MSO9064A-02

S E R V I C E N O T E

MSO9064A - 600MHz Mixed Signal Oscilloscope

Repair for Windows “Power surge on hub” message

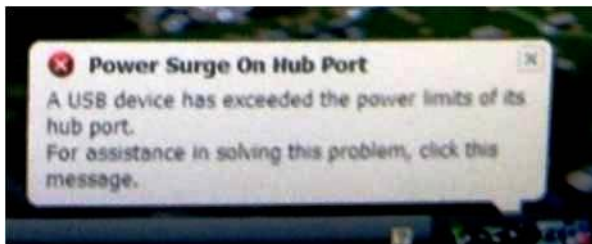
Situation:

A few scopes display the below message. This upgrade kit installs three components which will resolve the problem and the message should disappear. If the message still appears, either the upgrade was done incorrectly or the motherboard is actually defective.

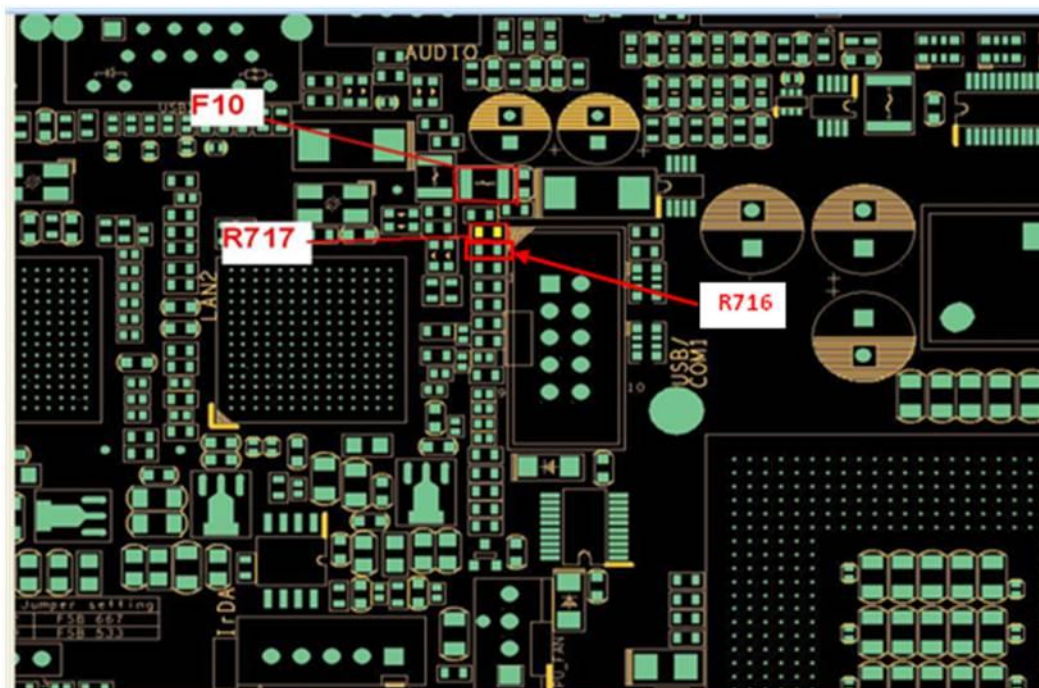
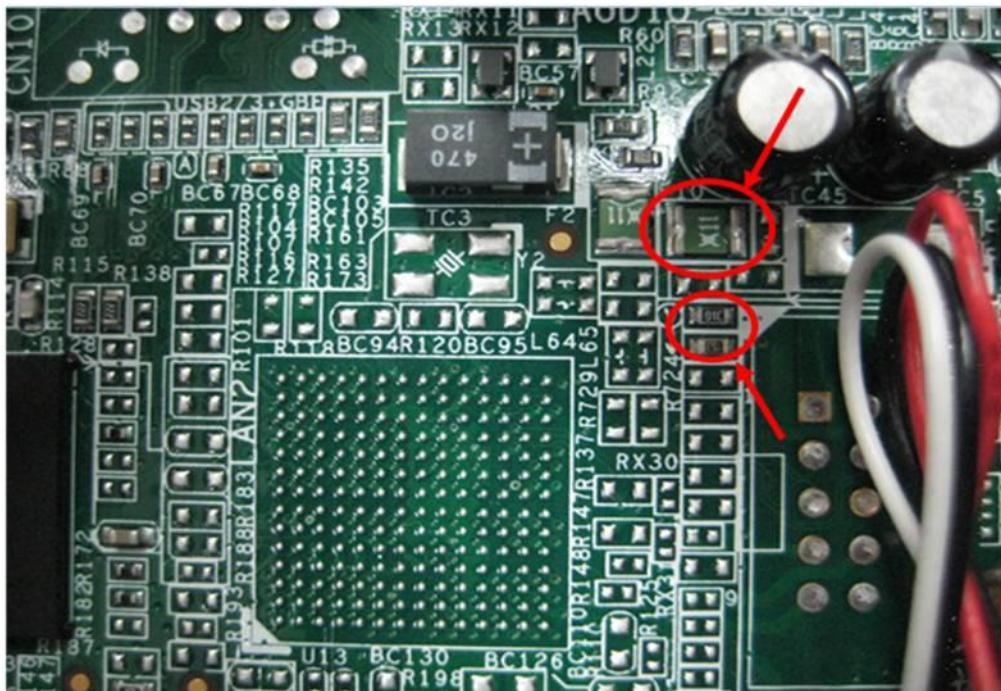
1. Refer to the service manual to remove the motherboard from the scope.
2. Install the three components from the upgrade kit on the motherboard. Refer to the below drawing and the drawing on the next page for component locations. The 0960-2789 motherboard is RoHS compliant and the below three components are also RoHS compliant. You should use a RoHS soldering station and RoHS solder techniques when possible.

F10 – 0837-3854 Thermistor

R717 – 0699-7654 10K Resistor

R716 – 0699-5789 15K resistor
